EASTBOURNE BOROUGH COUNCIL

EASTBOURNE PARK DISTRICT PLAN -

REVIEW OF HYDROLOGY AND HYDRAULICS

MAY 1987

Fig. 51 Estimates of 100-year flood hydrograph

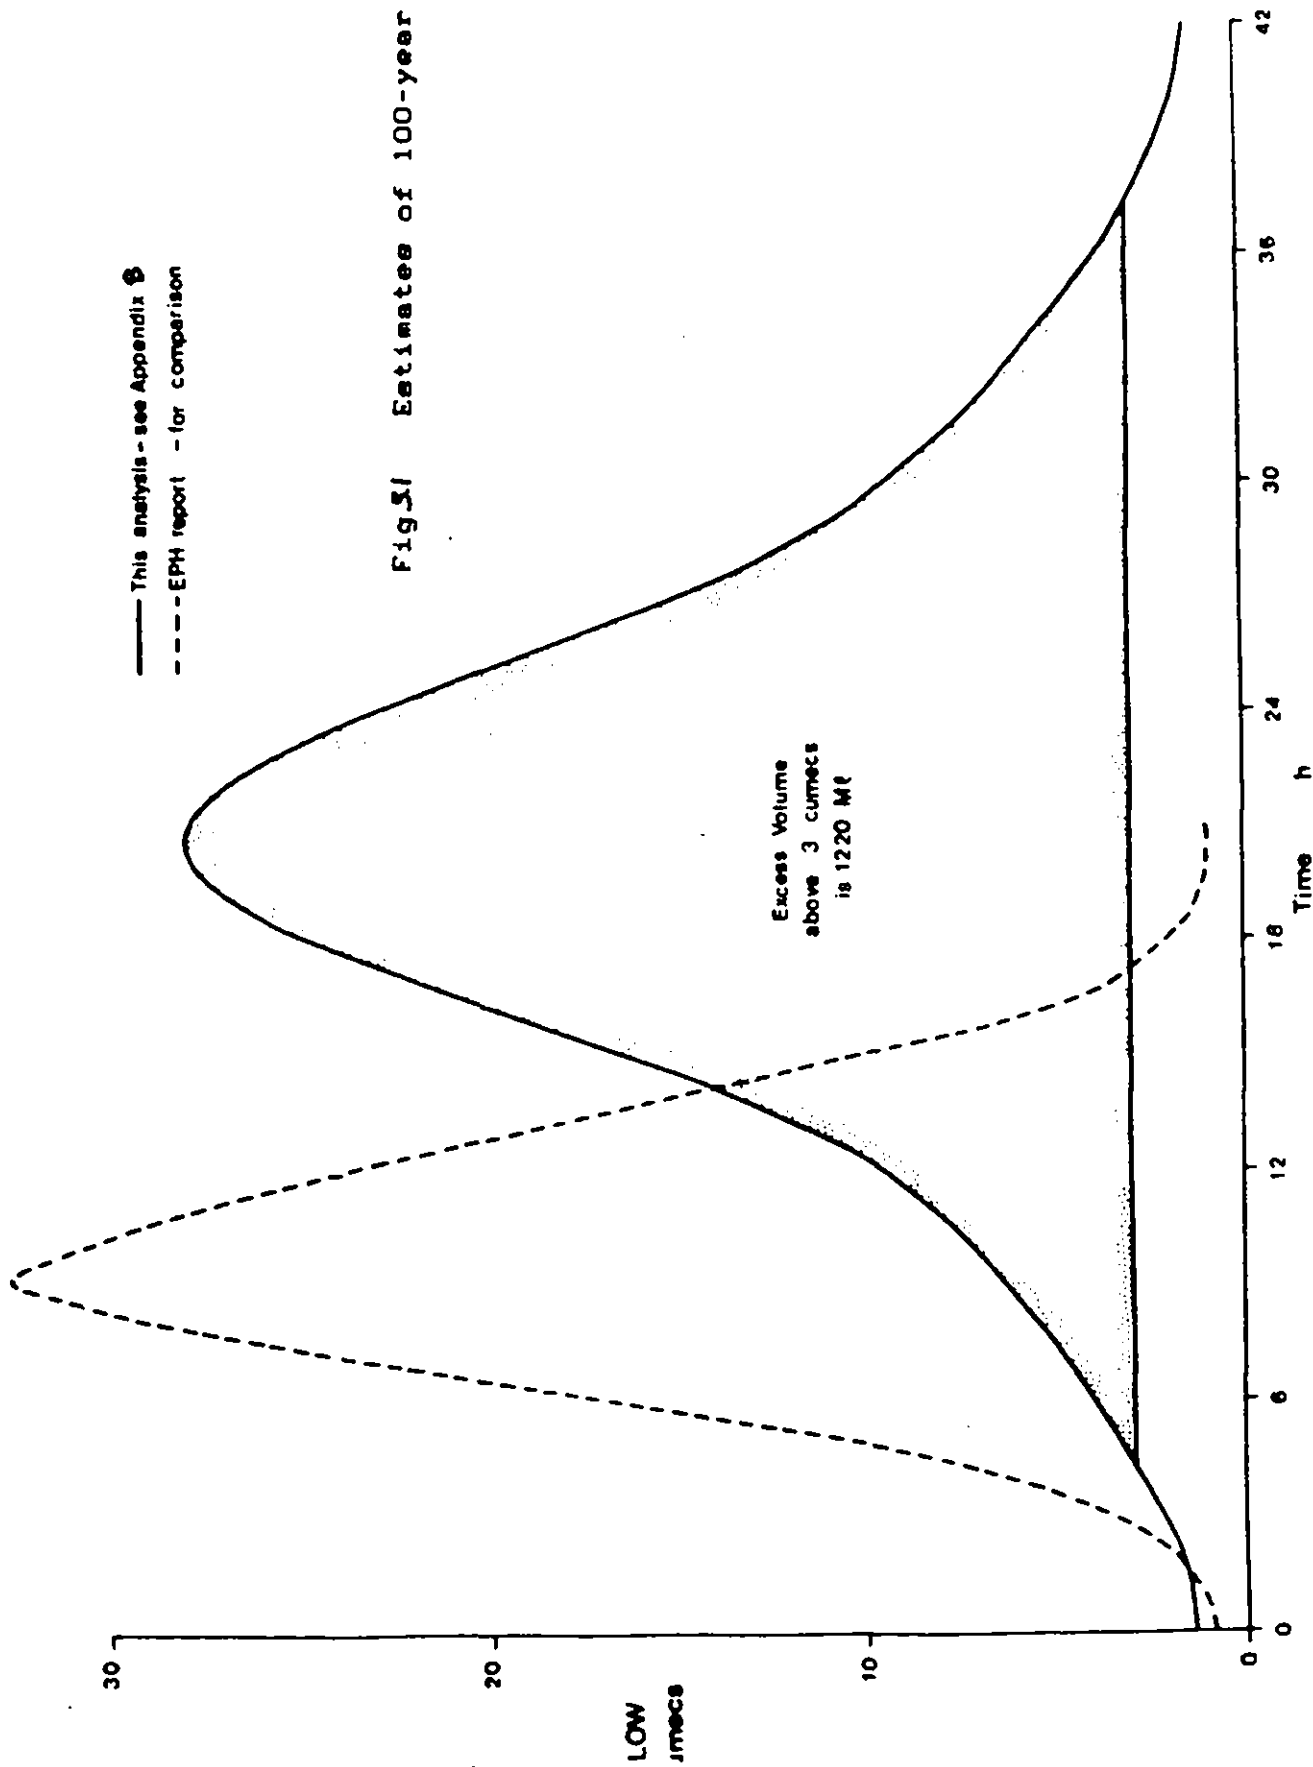
5.3 The 100 year flood hydrograph based on a 31 hour storm is shown in Figure 5.1. It is of a longer duration and has a significantly larger volume than the event adopted for use in the EPDP report. There are several reasons for this: some methodological and some interpretative. The following paragraphs consider in detail the more important aspects of the flood estimation.

Graph showing calculation of flow
in Langney Sewer at Langney Bridge
Figure 7.1

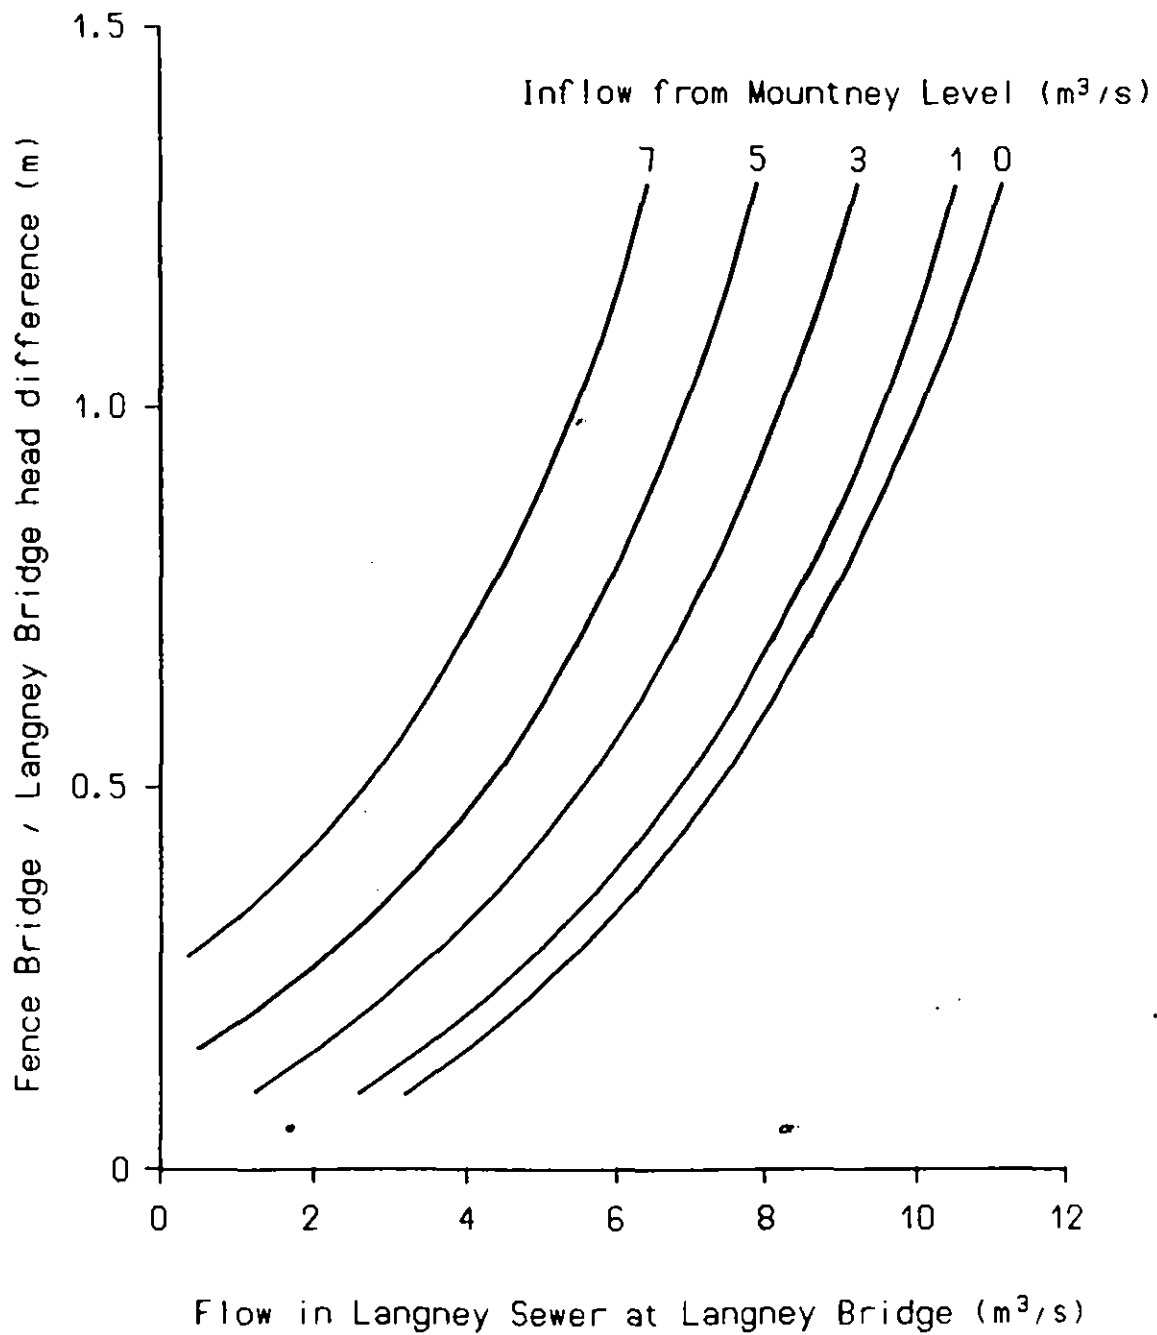
7.6 The results of our calculations are summarised on Figure 7.1. The figure shows how sensitive the discharge is both to the level difference between Langney Bridge and Fence Bridge and to the inflow

7.10 We have assessed the discharge at Langney Bridge for 3 January 1986 using Figure 7.1 on the basis of the observed or inferred water levels and assuming that direct drainage from the catchment downstream of Langney Bridge was half the runoff anticipated in the 100 year design storm. The results shown on Table 7.1 suggest an average discharge at Langney Bridge of between 2.7 and 3.9 m³/s depending on which water level curve is assumed to apply at Fence Bridge. This

Relationship between effective outlet capacity and maximum 100yr flood height on Willindon Levels
Figure 7.3

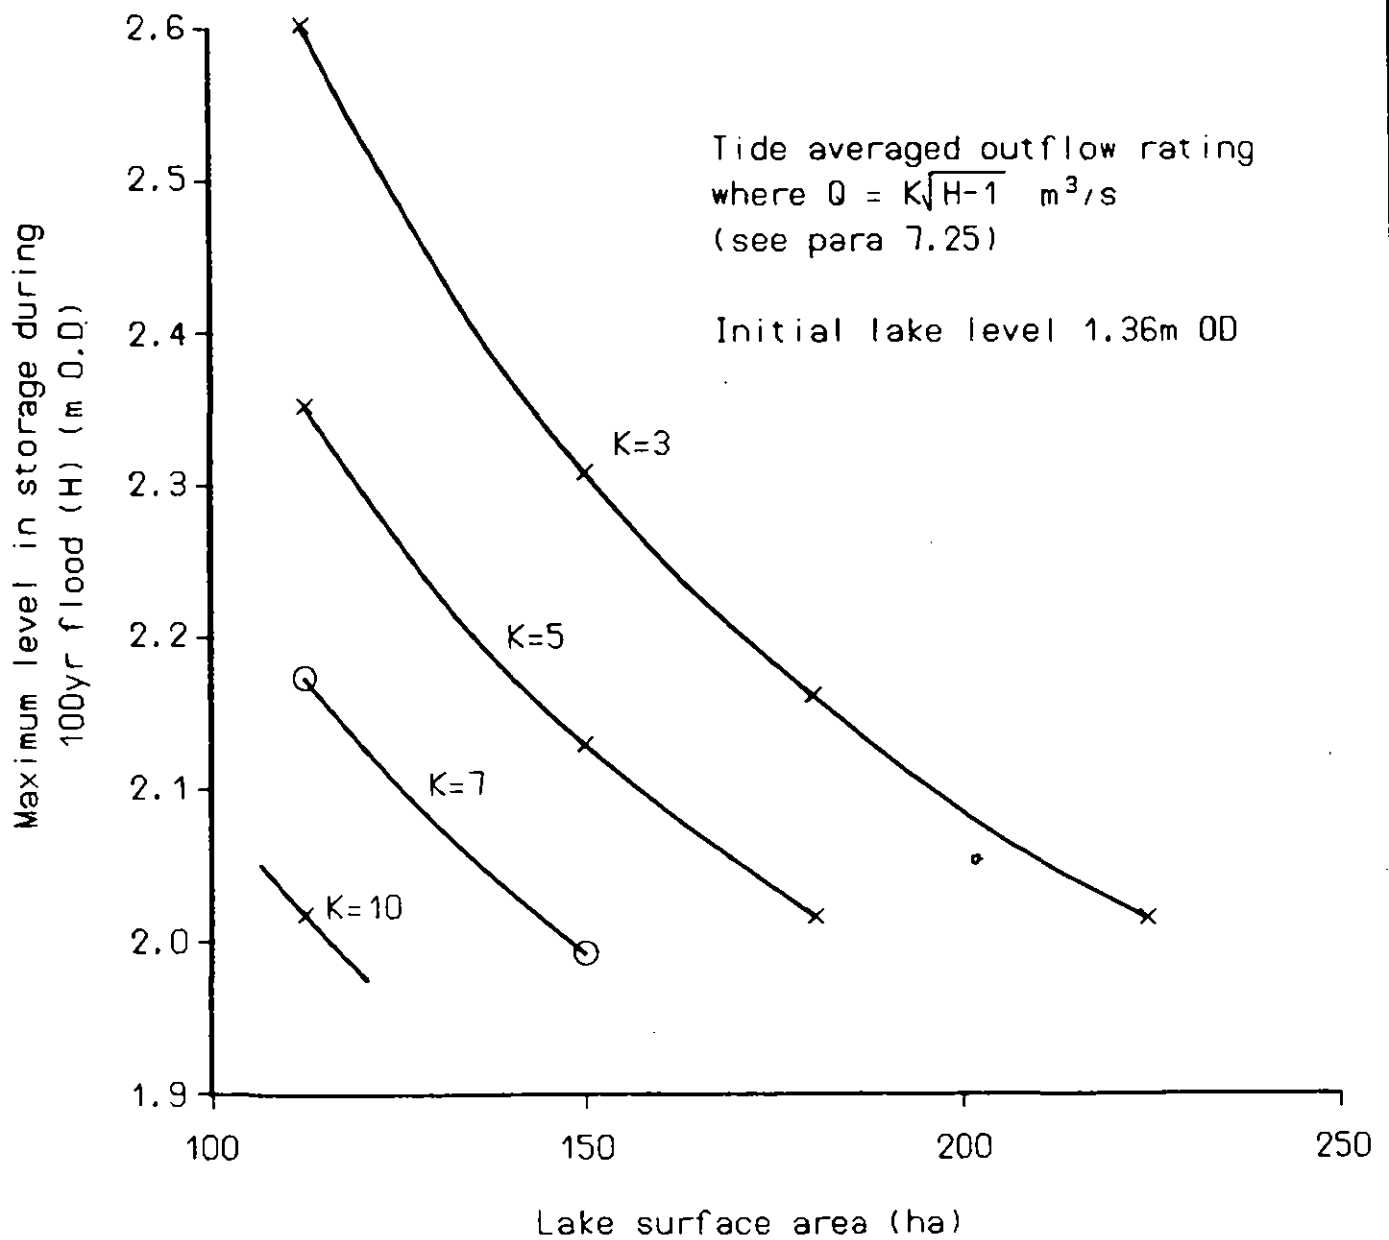
7.26 The effects of routing the updated 100 year design flood through the 112 ha lake area proposed in the EPDP report is illustrated in Figure 7.3. This demonstrates that the existing 24 hour average combined outlet capacity of around 3.0 m³/s through West Langney and Crumbles Sewers at 2.0 m OD would cause peak levels in the Willingdon Levels lake system of about 2.6 m OD. In practice somewhat lower levels would be expected because of the flooding of low ground around the lake system. This figure also suggests that the existing outlet capacity would need to be trebled to prevent water rising above 2.0 m OD in Willingdon levels in the design storm.
